**DRAINAGE LETTER REPORT**

**BENT GRASS PLAZA**

**September 20, 2023**

PPR2342

**PROPOSED DRAINAGE PLAN**  
 PROJECT NO. 21814-00CSCV  
 DRAWING NO.

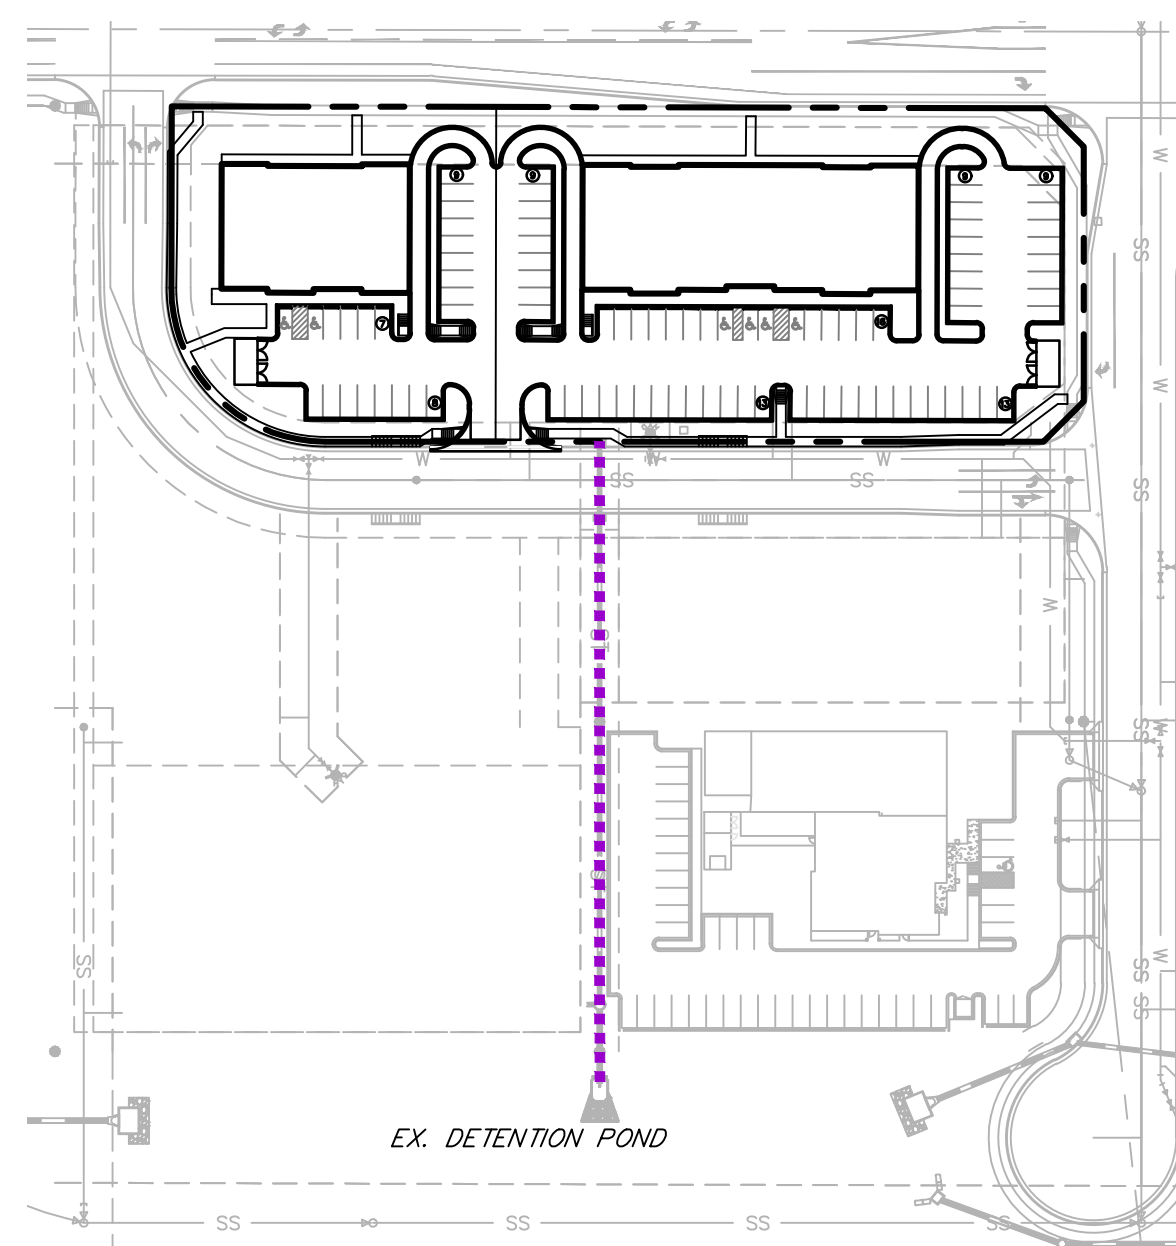
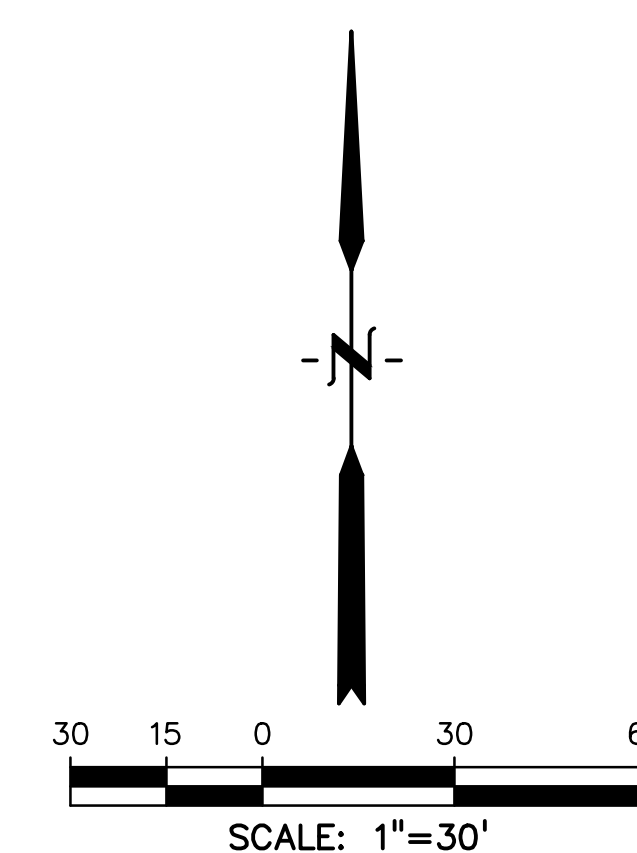
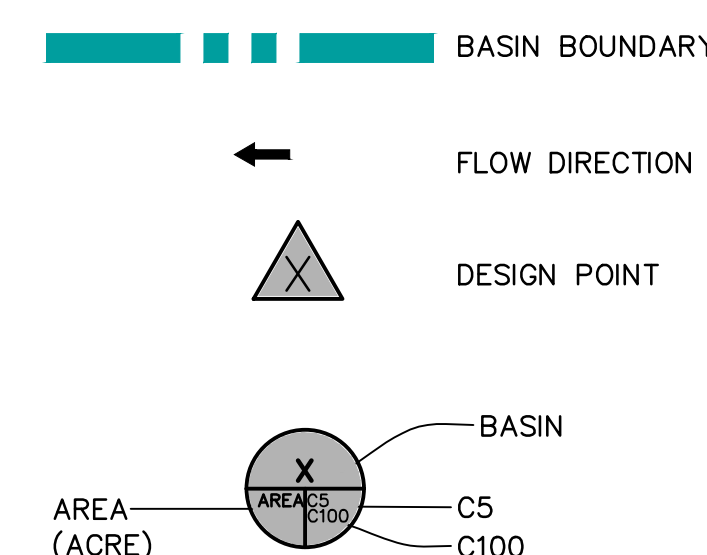
Please create a basic WQ treatment summary table (example provided below) on this map. For proposed disturbances that are not tributary to the pond, provide applicable exclusions. As stated above on PDF pg 6, the table should clarify how WQ is achieved for Basins G, H, I, K, and L (as all other Basins flows are explained in the text as being conveyed to Pond 2 via stormwater piping).
